TECHNICAL NOTE				VELOCITY4	
Client	Kitewood Estates Ltd.			Page No.	1 of 19
Project	Site A Willow Way, Sydenham			Project No.	22/089
Subject	Technical Note in Support of Planning Appeal			Document No	TN004
Prepared By	PM/AM	Checked and Authorised By	MK	Date	11 May 2023

**Table 1-1: LBL Officer Report Comments on the Application and VTP Response**

**Table 1-2: LBL Transport Comments on the Application and VTP Response**

PLAN SHOWING PARKING CAPACITY LOST BY PROPOSED DOUBLE YELLOW LINES

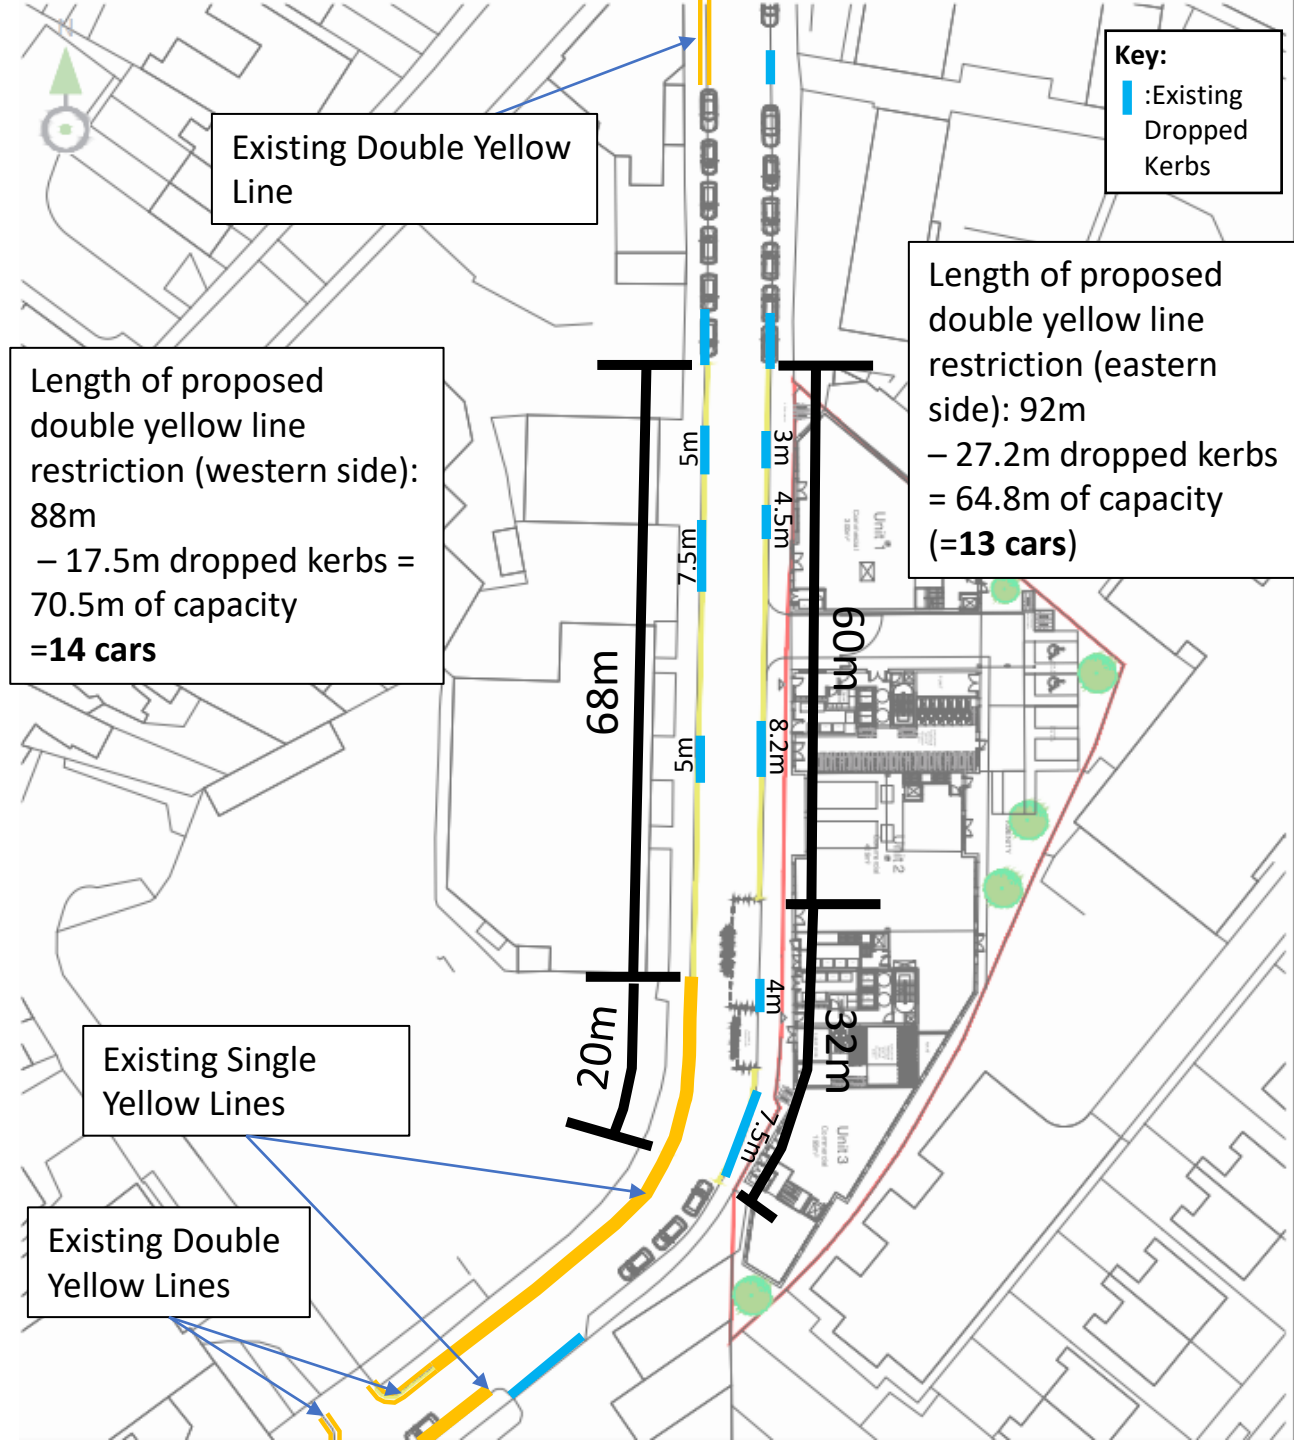
322	<p><b>Car Parking Demand:</b></p> <p>The Highways officer has provided the following comments: In order to assess the potential level of overspill parking within the immediate area a parking stress survey should be undertaken, and a census assessment should be completed to estimate the potential number of residents that would park on-street due to the no car parking restrictions. The applicant has provided a car parking stress survey and an assessment on 2011 census data. The parking survey map at Appendix E is not clear. The dropped kerb key is shown twice, and this will need clarification and correcting. Additionally the raw data associated with the survey has not been provided which is needed in addition to the map corrections. The summary provided within the TA at Table 6.2 shows very low parking stress which needs to be reviewed against the raw data.</p>	<p>The raw data from the parking survey has been included in <b>APPENDIX B</b> of this Technical Note for review. An amended version of the parking survey map has also been provided, correcting the duplicated "dropped kerb" reference in the key. The raw data demonstrates that the parking capacity and stress have been calculated accurately, taking dropped kerbs and crossings into account. As such, the error regarding the duplicated references in the key is considered to be immaterial.</p> <p>The raw data demonstrates that the low parking stress along Willow Way was reported correctly, with 10% and 13% of available parking space being occupied at the time of the surveys (01:00, Tuesday 28<sup>th</sup> and Wednesday 29<sup>th</sup> June respectively). The data also shows that the overall parking occupancy levels across the survey area were 49% and 54% on the survey days respectively, indicating there was spare capacity for up to 74 additional vehicles on Tuesday and 69 additional vehicles on Wednesday. The</p>

PARAGRAPH	PLANNING OFFICER / LBL HIGHWAYS COMMENT	VTP RESPONSE
		capacity figures also exclude the areas covered by single and double yellow lines for robustness, despite parking being legally permitted on single yellow lines in the study area after 18:30.
323	<p><b>Adjustment of Residential Trip Generation &amp; Parking Demand:</b></p> <p>The 2011 census data clearly shows that there is a potential that 12% of occupants of the residential units may drive and therefore will own a car which equates to 12 car parking spaces. The applicant adjusted this to 3% in line with the current London Plan policy requirements for the car-free nature of the site.</p> <p>The surveys indicate a spare capacity of 31 spaces on unrestricted parking spaces which would indicate sufficient capacity, but it should be noted the assessment of single yellow line and double yellow line parking availability is considered as restricted parking and not appropriate for this assessment.</p>	<p>It is noted that the 2011 census data suggests 21% of households may drive to work (not 12%) which could in theory forecast demand for 12 parking spaces. As noted by LBL, the parking survey demonstrates that there were 31 and 29 spaces available at the time of the Tuesday and Wednesday survey respectively along Willow Way. As shown in the raw data, single and double yellow lines were not included as unrestricted parking spaces and so the capacity for 31 and 29 extra vehicles does not take the single yellow line areas into account which could legally be parked on outside controlled hours. The analysis is therefore considered to be correct and robust.</p> <p><b>Parking sensitivity test for 12 resident vehicles</b></p> <p>While it is considered unlikely that the site will generate demand for 12 parking spaces, particularly in the context of current policy (and not that which would have been associated with the 2011 census data) should this level of demand have occurred during the parking survey and all 12 vehicles parked on Willow Way, there would have remained 19 and 17 parking spaces available over night during the survey period (plus the capacity of the single yellow line areas which can legally be parked in between 18:30 and 08:00). This parking demand on Willow Way would have equated to 49% on Tuesday and 54% on Wednesday which is far lower than the 80% typically considered to represent parking stress. This scenario also assumes that none of the 12 drivers had blue badges and therefore wouldn't have been able to park in one of the two on-site parking spaces provided from the outset of development.</p> <p>Double yellow line parking restrictions along Willow Way are proposed in order to control demand for parking and protect site user amenity. The following assessment demonstrates that the impact of the 12 vehicles would have taken account of the proposed double yellow line restrictions.</p> <p>Excluding dropped kerbs, the length of kerbside space proposed to have double yellow line restrictions amounts to approximately 70.5m of capacity on the western side of Willow Way, and 64.8m of capacity on the eastern side as shown in the plan in <b>APPENDIX E</b> of this Technical Note. Based on an average car length of 5m, this suggests the western side currently has capacity for up to 14 cars to park, and up to 13 cars on the eastern side. 20m of the western side already has single yellow line</p>

PARAGRAPH	PLANNING OFFICER / LBL HIGHWAYS COMMENT	VTP RESPONSE
		<p>restrictions (i.e. space for four cars) which is already considered as restricted parking. Therefore, this amount has been deducted from the total number of spaces being removed. The number of spaces lost is therefore 10 on the western side and 13 on the eastern side. The number of spaces able to be parked in on Willow Way would therefore reduce from 37 to 13 (13.94 rounded down).</p> <p>As the parking survey undertaken for the application was performed at night-time, the daytime demand for parking along the stretch of Willow Way proposed to be restricted by double yellow lines is not known. As such, the night-time demand has been used in the first instance. This is in line with the standard Lambeth Methodology.</p> <p>There were 6 cars parked in unrestricted kerb space on Willow Way on the Tuesday survey and 8 cars parked on the Wednesday survey. As such, the potential addition of 12 resident cars would exceed the new unrestricted capacity of 13 vehicles along Willow Way. Adding the 12 cars to the other roads in the survey area would result in an increase in demand from 49% to 69% based on the Tuesday survey demand, and from 54% to 75% based on the Wednesday survey demand (taking into account the reduced overall capacity due to the new double yellow line restrictions). As such, the area surrounding the site could accommodate the demand in the unlikely event that the site generated 12 additional vehicles. Should a CPZ be introduced in the local area, the future residents would also be exempt from obtaining parking permits, which further makes this scenario unlikely to be realised.</p> <p><b><u>Assessment of displaced parking due to proposed double yellow lines</u></b></p> <p>It is acknowledged that the proposed introduction of double yellow lines may result in some displaced existing on-street demand from Willow Way onto surrounding streets. The vehicles using the eastern side of Willow Way along the Site A frontage (which is proposed to become double yellow line restricted) can reasonably be considered to relate to the existing uses of Site A. As such, following the redevelopment of the site, it is expected that this demand will no longer occur.</p> <p>The kerbside space on the western side of Willow Way subject to the proposed double yellow line restrictions can be considered to relate to Site C, which is currently used as a catering supplier.</p>

PARAGRAPH	PLANNING OFFICER / LBL HIGHWAYS COMMENT	VTP RESPONSE
		<p>As calculated earlier, the western side of Willow Way subject to the proposed double yellow line restrictions would reduce the parking capacity by 10 vehicles.</p> <p>Assuming a maximum of 10 vehicles are displaced from the western side of Willow Way to the surrounding streets within 500m of the site (which is also the area covered by the parking survey), the parking occupancy in the survey area would increase from 49% to 53% based on the Tuesday survey demand, and from 54% to 57% based on the Wednesday survey demand. This includes two vehicles which were parked on the eastern side of Willow Way outside of the proposed double yellow line restricted area on both nights of the survey.</p> <p>In the event that the site generated 12 resident vehicles which also parked in the survey area, the overall occupancy would increase to 74% on the Tuesday and 78% on the Wednesday.</p> <p>It is therefore reasonable to assume that the drivers of the vehicles which have historically parked on the western side of Willow Way would be able to find an alternative parking space within the survey area if needed, with a maximum walking time of 5 minutes from the site.</p>
